## Response to Submissions

### Central Park

Modification to Approved Concept Plan MP 06\_0171 (Mod 8)

On Behalf of Frasers Broadway Pty Ltd

**Figure 1** – Commercial versus residential massing

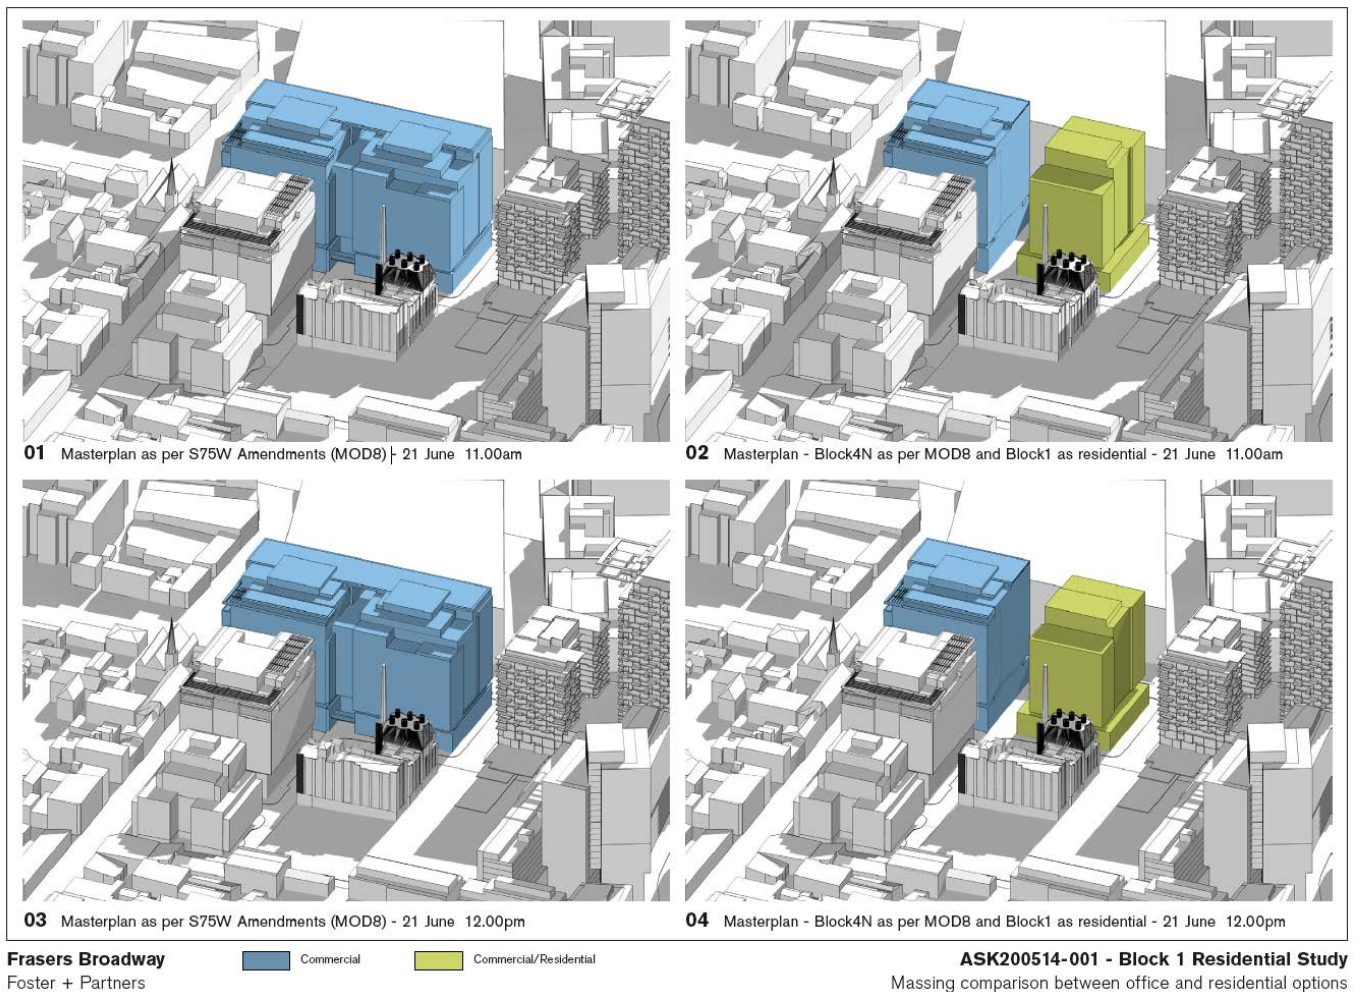
- the potential impacts on the Central Pak site in terms of providing a balanced, mixed use, urban development;
- the potential amenity of future residents within Block 1 and the Brewery Yard Buildings, taking into account SEPP 65 and the accompanying Residential Flat Design Code;
- the potential heritage impacts resulting from the proposed use of the Brewery Yard Buildings for residential uses;
- the impacts of the proposed change on on-site parking provision; and
- the potential future demand for commercial floor space in light of BIS Shrapnel's research.

Notwithstanding this, a preliminary study undertaken by Foster +Partners (refer to **Appendix B** and **Figure 1**) demonstrates that a residential scheme on Block 1 could have a number of positive environmental impacts. A summary of potential impacts / benefits arising from the proposed change is provided below:

- the approved building heights would generally be maintained, whether residential or commercial uses are developed on Block 1 and the Brewery Yard;
- due to the requirements of SEPP 65 and the need to provide residential amenity, the residential Block 1 envelope would potentially be narrower than the commercial envelope, with greater setbacks from Block 2 and Block 4N, and the potential for separation at the ground level;
- the redevelopment of Block 1 for residential purposes would enhance public amenity through increased public domain (between Blocks 1 and 4N), resulting in less overshadowing and more solar access to the Brewery Yard forecourt and Chippendale Green; and
- the Brewery Yard envelope (being a heritage item) would be maintained.
